Our Ref: F2025/00890
(Contact Officer: Joseph Edmonds, ph: 9093 6955)

Reference number	SSD-81426710
Subject Land	138 Maroubra Road, Maroubra
Proposal:	Construction of a nine-storey mixed-use development comprising a residential flat building and ground floor retail premise, including: - 27 x 1-bed apartments, including 7 affordable dwellings - 14 x 2-bed apartments, including 6 affordable dwellings - 23 x 3-bed apartments - Communal open space at rooftop level and on level two Replacement of an existing single level of basement to provide basement car parking, plus additional parking provided above ground on the first storey. The application is seeking an infill affordable housing bonus under the SEPP Housing 2021, noting that 13 affordable housing units are proposed within the scheme.

I refer to your request for Council's review of the Mixed-use development with in-fill affordable housing at 138 Maroubra Road, Maroubra. The following comments are provided for your consideration.

Figure 2: Section showing the height of the pergola (Source: Applicant)

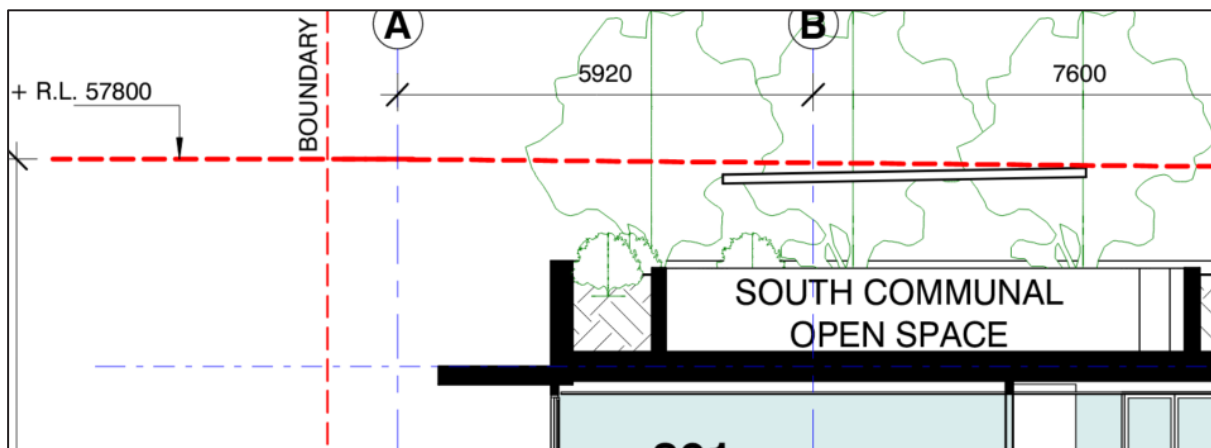
Councils' methodology for measuring building height is to take the existing ground level (being the underside of the existing basement level slab) RL 22.52 and calculate what the building height is based off the maximum height of the building in accordance with the most recent direction of the NSW LEC.

The maximum overall height of the development being the pergola structure is at RL 57.8, as shown below.

The maximum building height is 35.28m. Therefore, the development exceeds the AFH Bonus height of 32.5m by 8.55%.

No Clause 4.6 Variation Request has been provided for assessment and as such it is not considered that consent cannot be granted in the absence of a variation request.

Figure 3: Inequitable share of building separations with the Police Station (Source: Applicant)

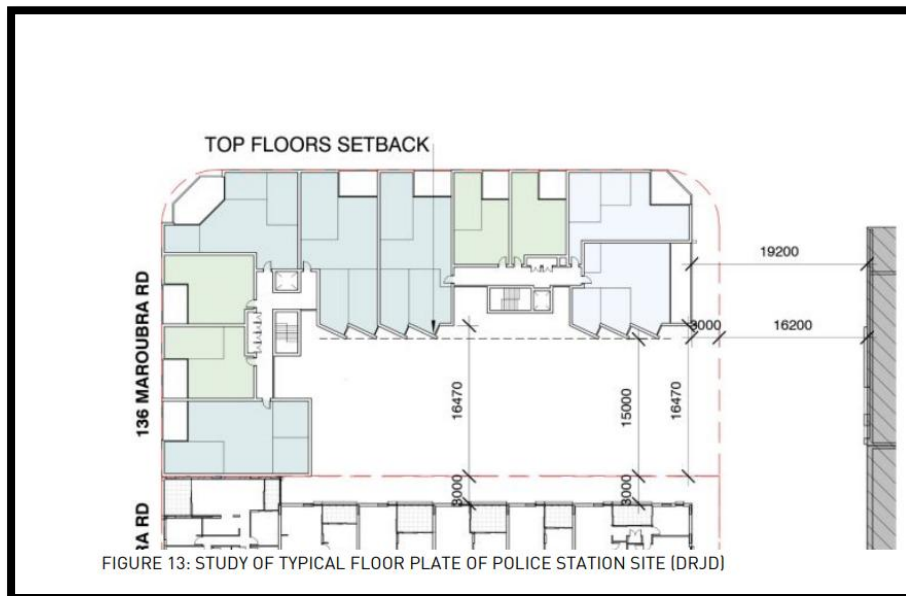
- On the southern frontage there is a nil side setback to the east and west from level 1 to level 8. These are blank walls.
- The terraces on the 2nd floor also provides a nil side setback to the west and a nil rear setback to the north. The communal open space has a nil side setback to the east.
- From levels 3 – 8, there is a 3m side setback to the west.
- The rear side setback is 3m and the eastern side setback to the east is 6.45m.

These separations and setbacks are not supported. Concern is raised for the proposed western side setback. It is not considered reasonable for the applicant to assume the redevelopment of the neighbouring property, without any formal block plan. The share of setback distances are not equitable, noting that the development site provides 3m, whereas the adjoining site is being expected to provide a minimum of 15m.

Figure 4: Western Elevation showing the configuration of the proposed balconies (Source: Applicant)

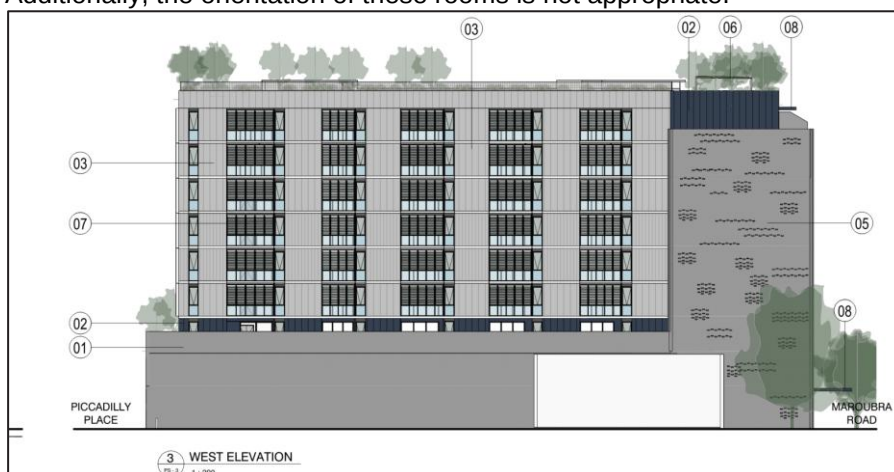
The side facing balconies to the west are not appropriate. These balconies are enclosed on three sides and as shown below proposed to be fitted with windows and louvres in a wintergarden arrangement. Council does not consider these afford sufficient amenity to future occupants in terms of private open space.

Additionally, the orientation of these rooms is not appropriate.

Figure 6: Block 6 Plan in the Maroubra Junction DCP (Source: Draft RDCP 2025)

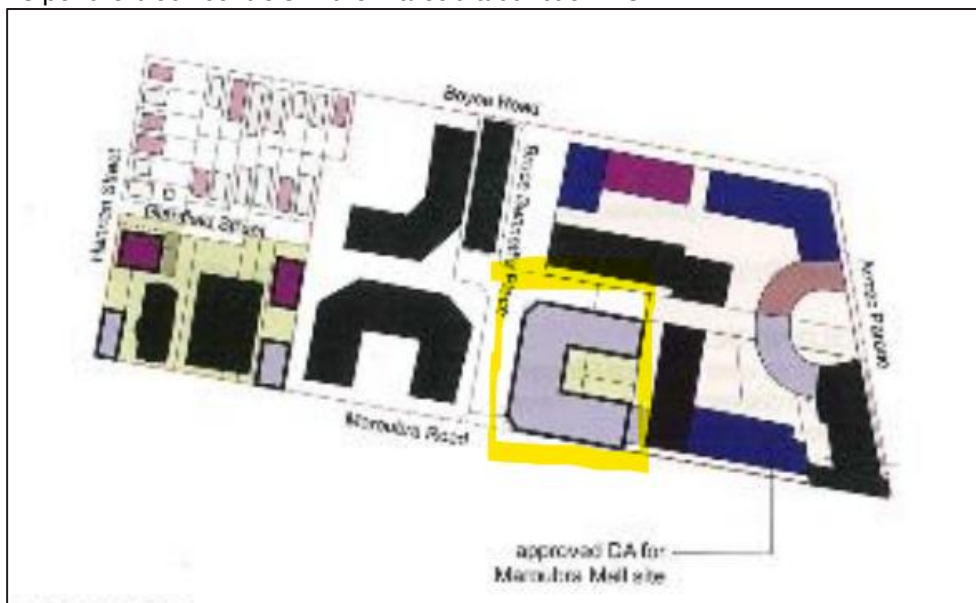
As shown in the Eye of the Sun Diagrams much of the development will not receive sunlight in the case of a similar scale redevelopment of the Police Station to the west and that sunlight access would be predominantly lost from 1:30pm to 3pm.

The building envelope plan anticipates a maximum of 6 stories along Maroubra Road. It also states that between Anzac Parade and Bruce Bennetts Place, there should be two levels of retail/commercial with residential above that is not provided in the subject scheme.

The proposal does not reinforce Anzac Parade as the main street or Maroubra Road as the secondary Street. The scale of the proposed building does not reinforce the junction (the corner of Maroubra Rd and Anzac Pde) as the main focus of the centre and will not provide a transition in scale.
